PRODUCT UPDATE INFORMATION

#1 - Golight's part number will not change!! We will still only offer 1 security dome part number. **Golight #17920**

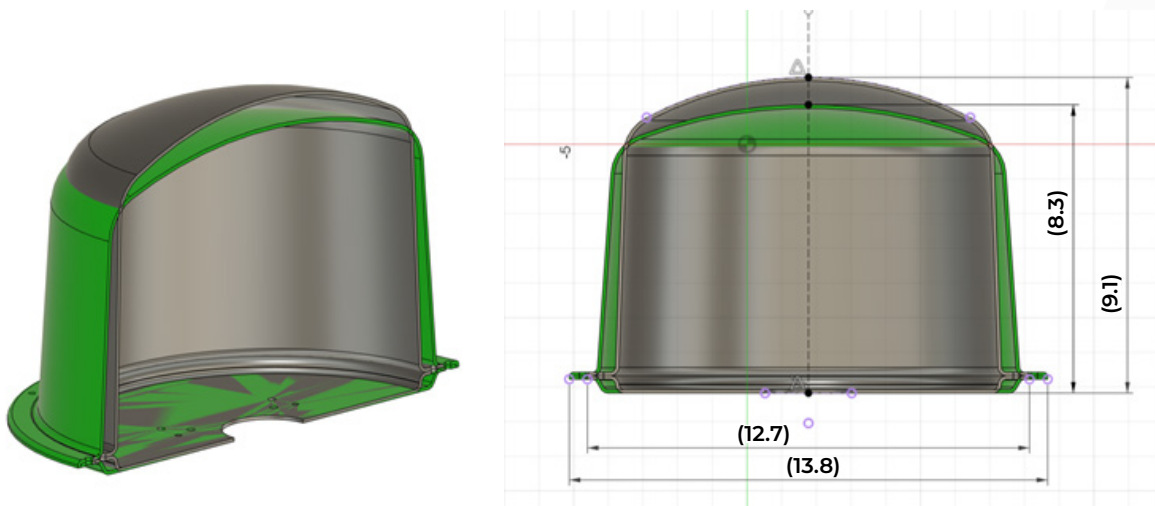
This new shape is an answer to feedback that we received from many field applications.

#2 - The slight change to the dome shape now allows it to be used for both the Golight GT and Stryker ST permanently mounted products.
(previous shape was only compatible with the Golight GT series)

In the below comparison images, provided by our engineering department, our new security dome is shown in green, and the previous style dome is represented in grey:
